51-53 HATTON GARDEN

RELOCATION OF ROOF PLANT

1.0 SUMMARY OF AMMENDMENT
ROOF PLANT RELOCATION

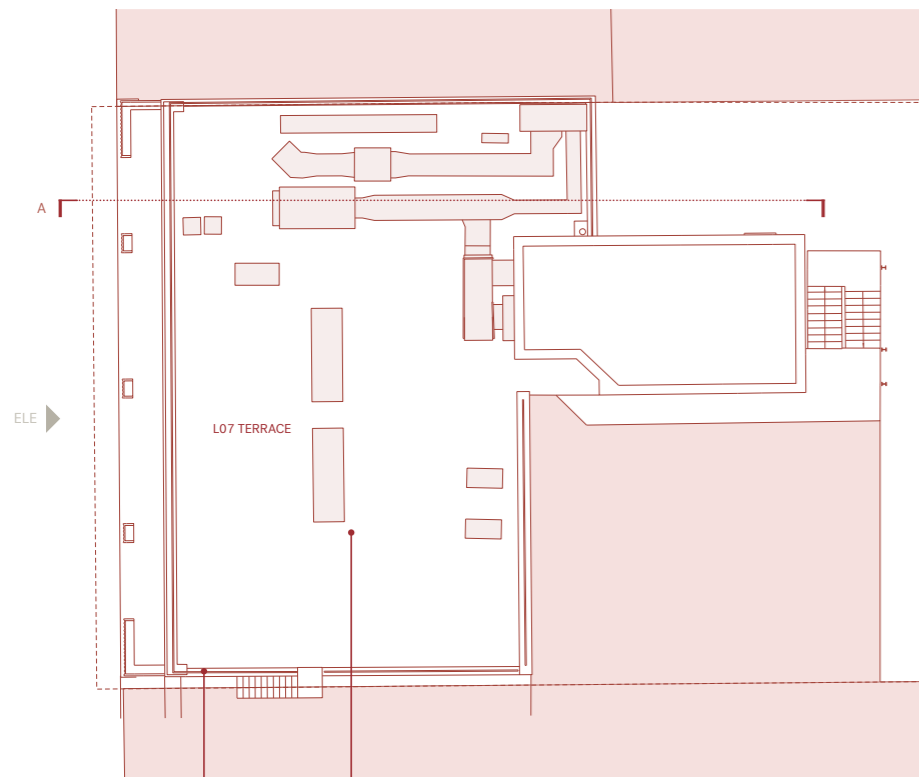
On 1st October 2020 planning was secured for the proposal of a new plant and terrace on 51-53 Hatton Garden. In ammendment to the consented scheme, we propose alterations to the location of the roof plant and addition of photovoltaic panels on the existing core roof.

In the consented scheme the new plant equipment was relocated above the existing core shaft and was hidden by way of a new hit and miss brick screen.

The new aspiration is to relocate the proposed plant equipment from the core roof (L08) to the corner of the roof terrace (L07) to reduce the new loads on the core roof and lower the height of the building. We are still retaining amenity space and greenery on L07 terrace as in the consented scheme. This proposal frees up space for photovoltaics on the roof.

In addition, the doors opening onto the 6th floor terrace will be changes from 2 new doors to 1 new door.

2.0
SUMMARY OF PROPOSED ALTERATIONS:
ROOF PLAN

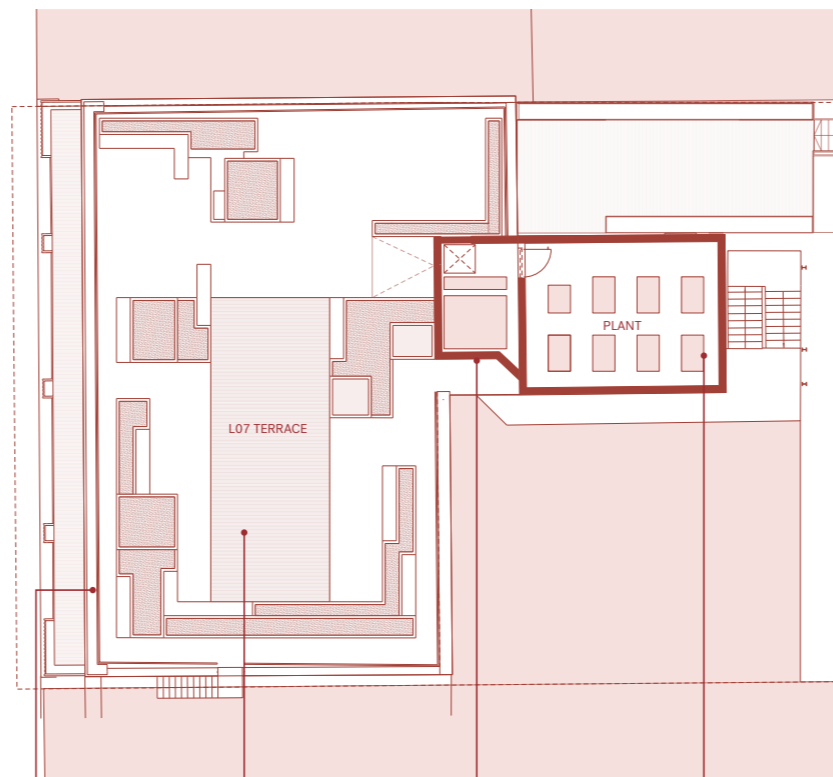
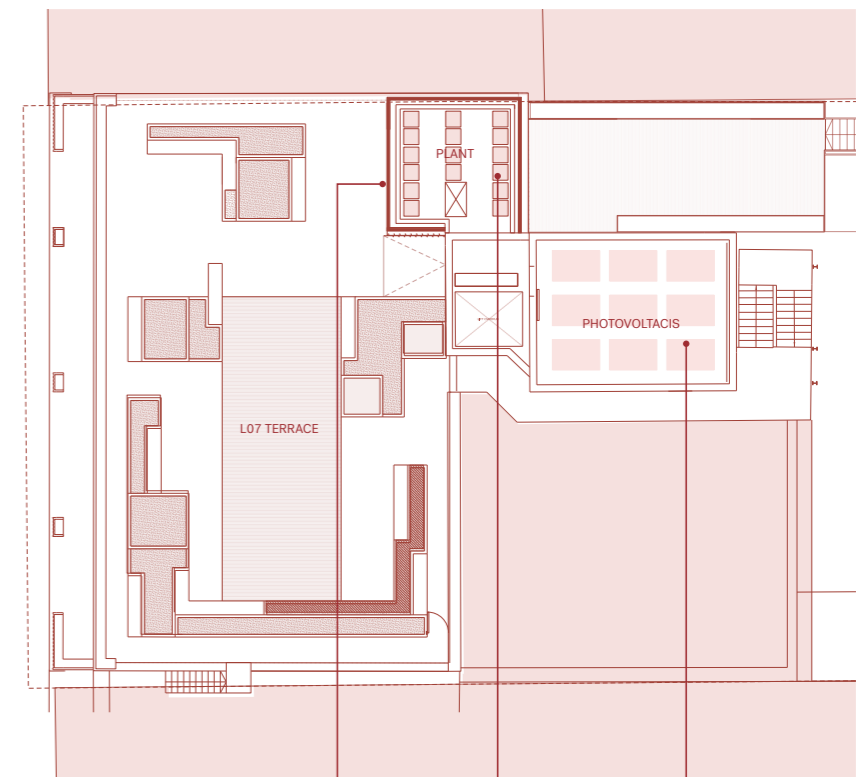
Outdated and unsafe railings to be removed

Roof plant equipment to be removed

New white metal railings

Proposed greening of terrace, please refer to landscape architect supporting documentation for more detail

Proposed buff hit and miss brick plant screen

Consented scheme relocation of roof plant equipment

Proposed buff hit and miss brick plant screen with inset acoustic louvre

Proposed relocation of roof plant equipment

Proposed location for photovoltaics

2.1 SUMMARY OF PROPOSED ALTERATIONS: FRONT ELEVATION

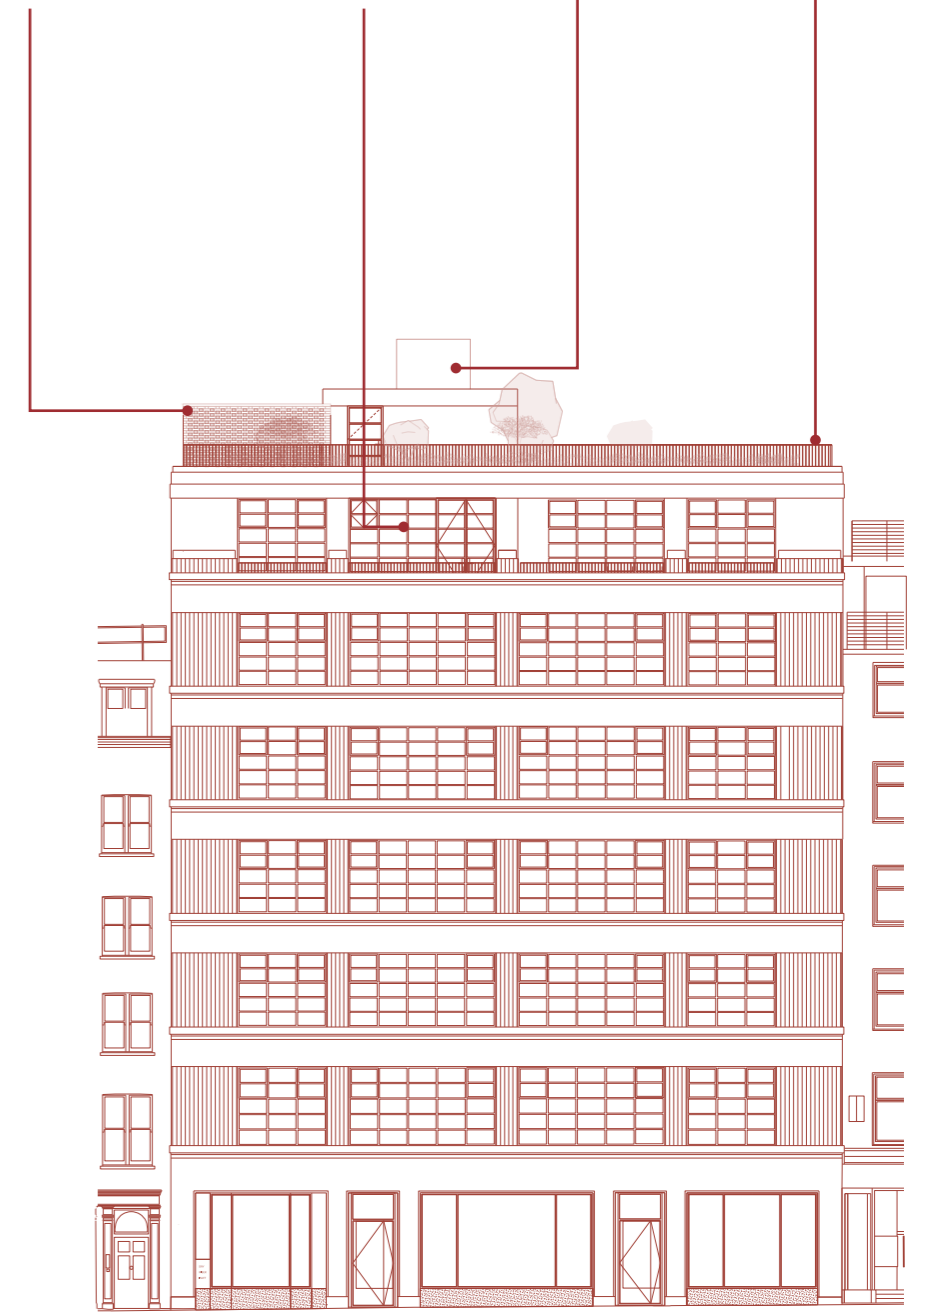
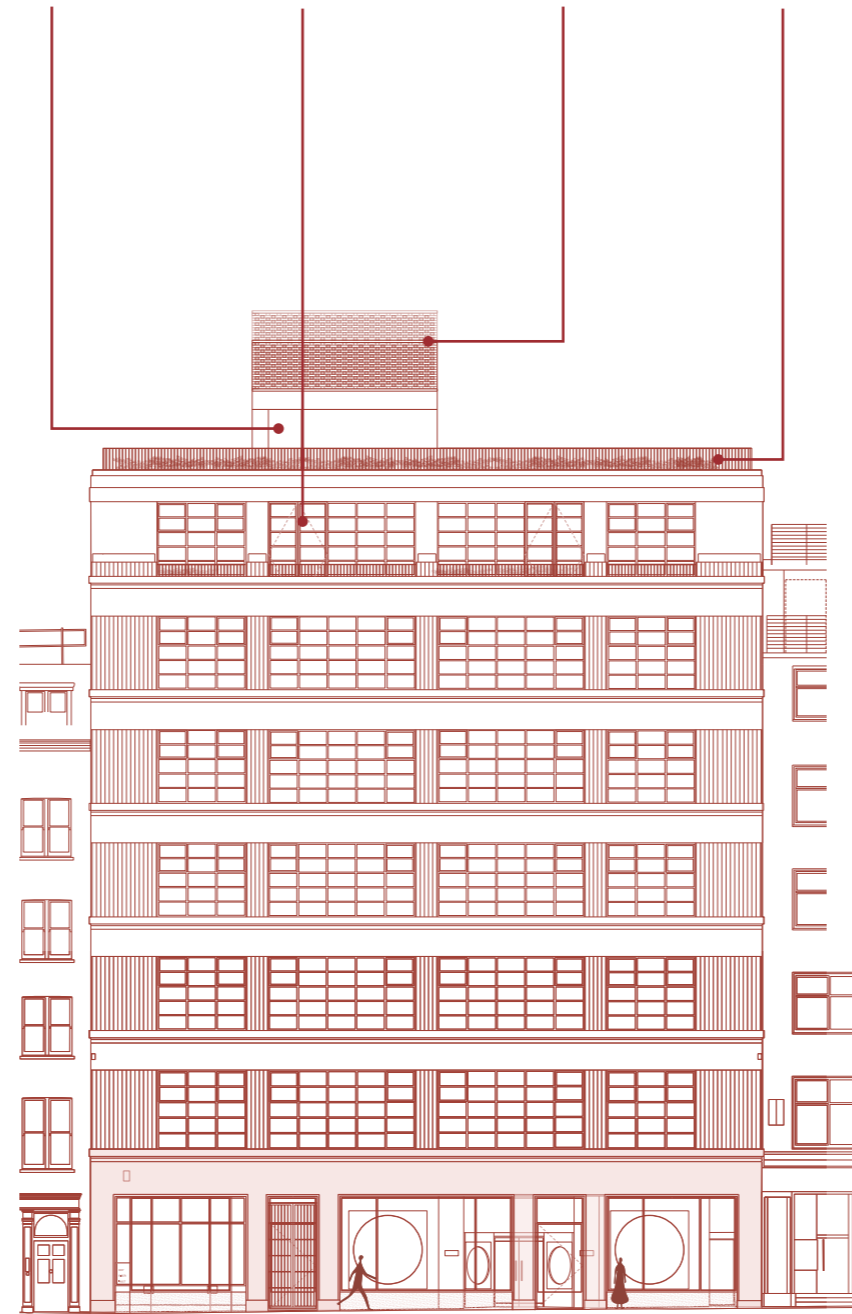
Roof plant equipment to be removed

Outdated and unsafe railings to be removed

New L07 roof terrace accessed via existing core

New L06 terrace with two new doors and white railings installed

New roof plant including lift overrun

Proposed white metal railings

Proposed hit and miss buff brick plant screen

New L06 terrace with one new door and white railings installed

Consented Lift overrun with brick cladding

Proposed white metal railings

2.2
SUMMARY OF PROPOSED ALTERATIONS:
REAR ELEVATION

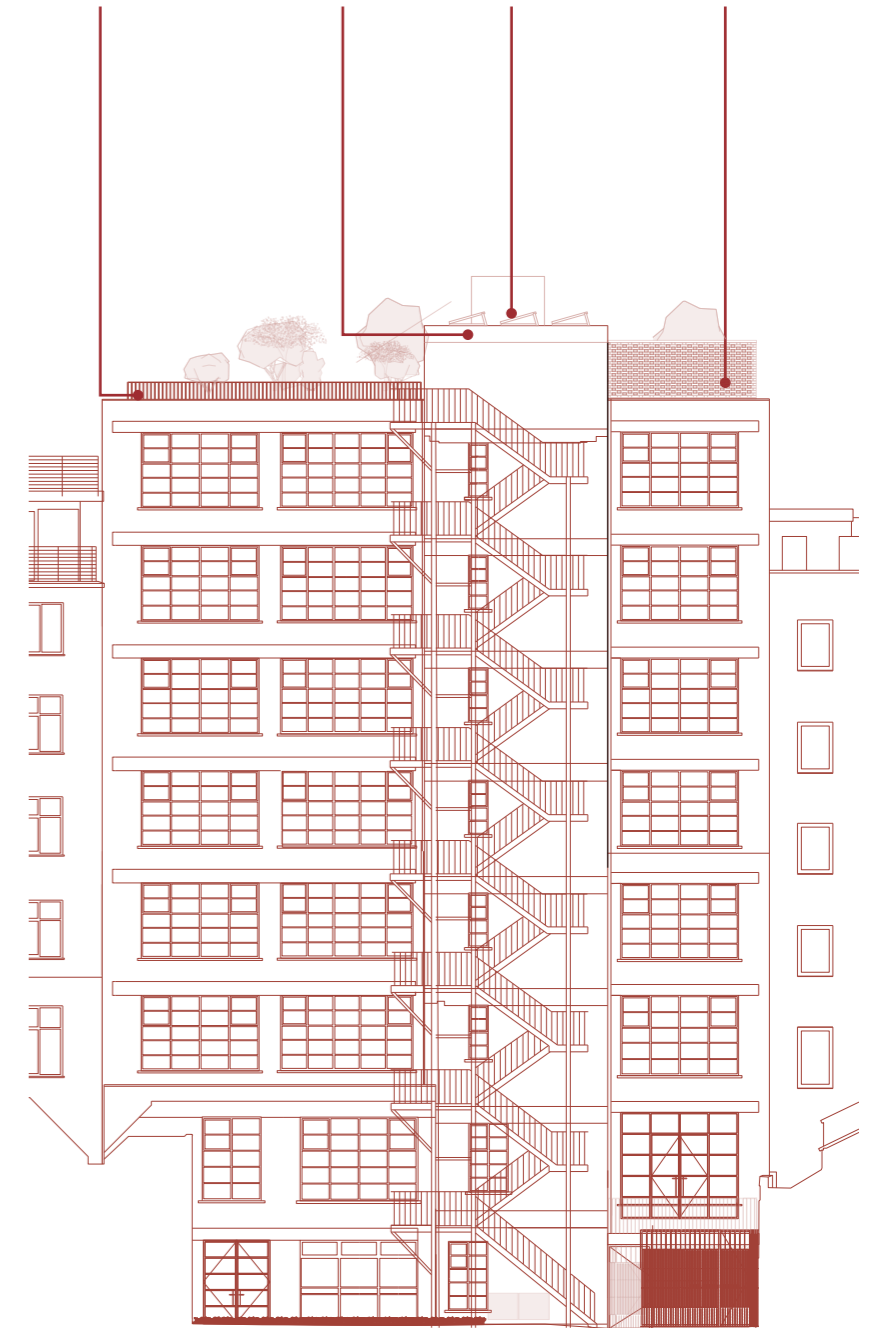
Outdated and unsafe railings to be removed

Proposed white metal railings

Proposed hit and miss buff brick plant screen

Proposed white metal railings

Proposed photovoltaics

Consented Lift overrun with brick cladding

Proposed hit and miss buff brick plant screen
